Access Compliance Report

Public Rights-of-Way

Intersection ID: N/A	Main Street: PROVIDENCE_COUNTRY_CLUB_DR	Cross Street: SOUTHMORE_DR	Location: NE
ADA ID: 7DF8659638CB	Ramp Type: PerpDiag	Initial Pass/Fail: Fail	Overall Compliance: No
Severity Score: 13.75			
Codes/Mitigation Info/Possible Solution		Field Measurements/Component Compliance

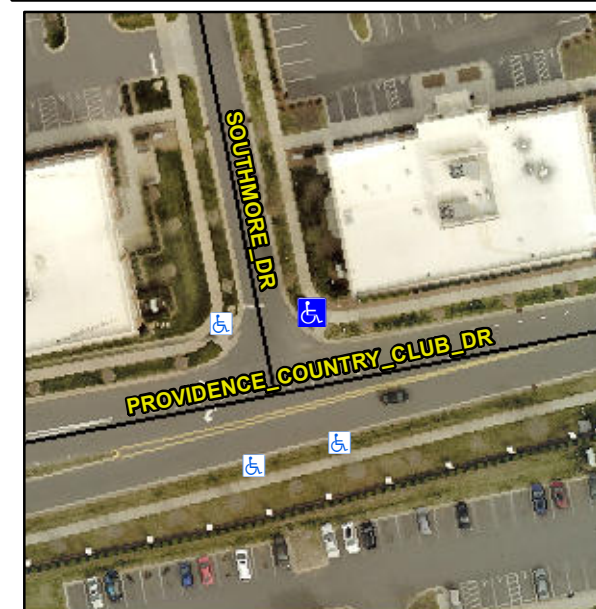
Not Found, R304.2.2, R304.5.3

Compliance	Description	Data	Compliance	Description	Data
N/A	Ramp Length (in)	93.0	No	Ramp Slope (%)	8.8
Yes	Ramp Width (in)	48.0	No	Ramp XSlope (%)	3.8
N/A	Flare Type LT	N/A	N/A	Flare Type RT	N/A
N/A	Flare Slope LT (%)	N/A	N/A	Flare Slope RT (%)	N/A
N/A	Flare Traversable LT?	N/A	N/A	Flare Traversable RT?	N/A
N/A	Landing Length (in)	N/A	N/A	DWS Provided?	N/A
N/A	Landing Width (in)	N/A	N/A	DWS Contrast?	N/A
N/A	Landing Slope (%)	N/A	N/A	DWS Length (in)	N/A
N/A	Landing X Slope (%)	N/A	N/A	DWS Full Width?	N/A
N/A	Landing Curb? (Y/N)	N/A	N/A	DWS Offset (in)	N/A
N/A	Shared Landing?	N/A			
N/A	Gutter Ponding?	N/A	N/A	Gutter Slope (%)	N/A
N/A	Gutter Lip Ht (in)	N/A	N/A	Gutter X Slope (%)	N/A
N/A	Painted X Walk1?	No	N/A	Painted X Walk2?	No
	X Walk 1 Direction	To W		X Walk 2 Direction	To S
N/A	X Walk 1 Width (in)	N/A	N/A	X Walk 2 Width (in)	N/A
	X Walk 1 Slope (%)	0.1		X Walk 2 Slope (%)	0.7
	X Walk 1 X Slope (%)	0.1		X Walk 2 X Slope (%)	0.9

Remove & Replace Curb Ramp With Two New Directional Ramps or Equivalent.
